# 2015 - 2016 Corvette: Service Bulletin: #16-NA-014: Delayed Engagement After Sitting With Engine Off

## #16-NA-014: Delayed Engagement After Sitting With Engine Off - (Jun 28, 2016)

**Subject:** Delayed Engagement After Sitting With Engine Off

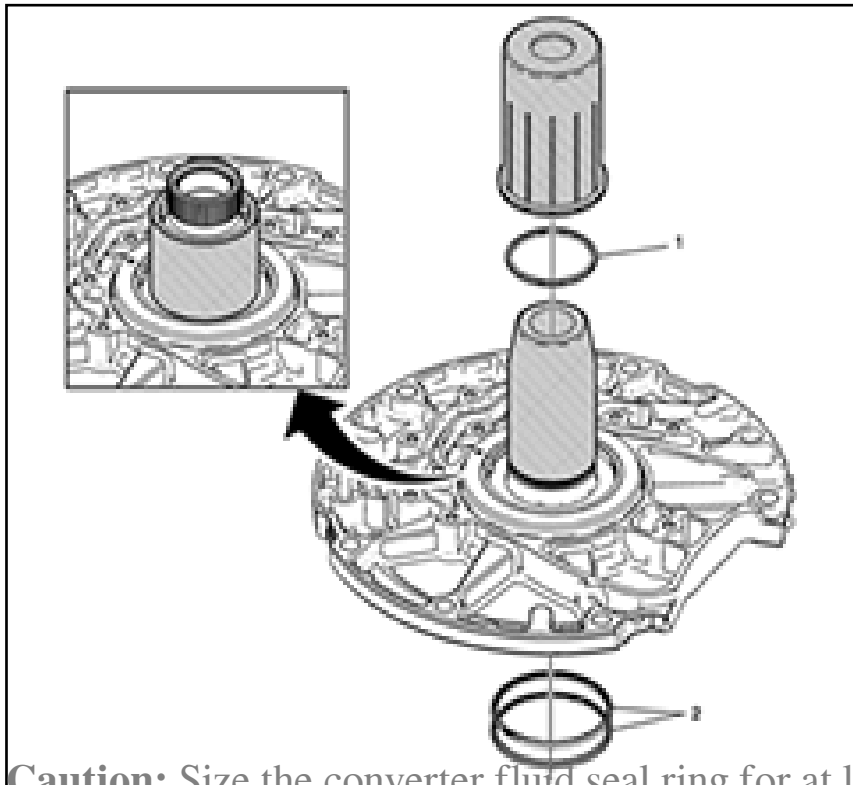
(A)

Old stator support asm

(B)

New stator support asm

**Note:** The new stator shaft support assembly has a second check ball (1) added (see illustrations).

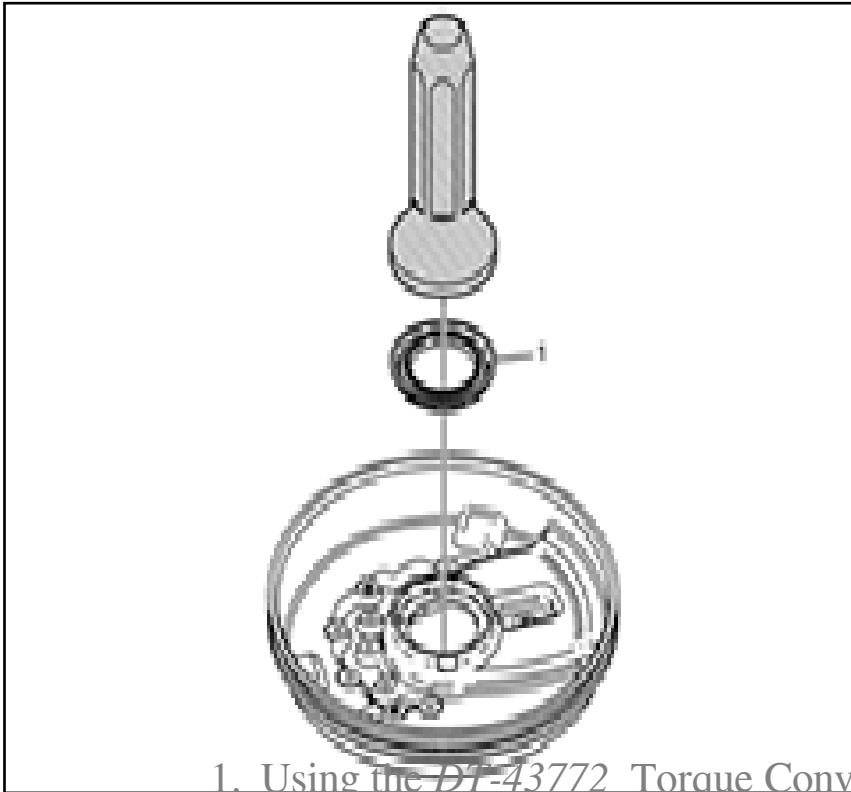
(A)

Old cover - 8L90 Only

(B)

New cover - 8L90 Only

**Note:** The casting void has been eliminated from the underside of the cover for the 8L90 only (see illustration). The 8L45 is not required.
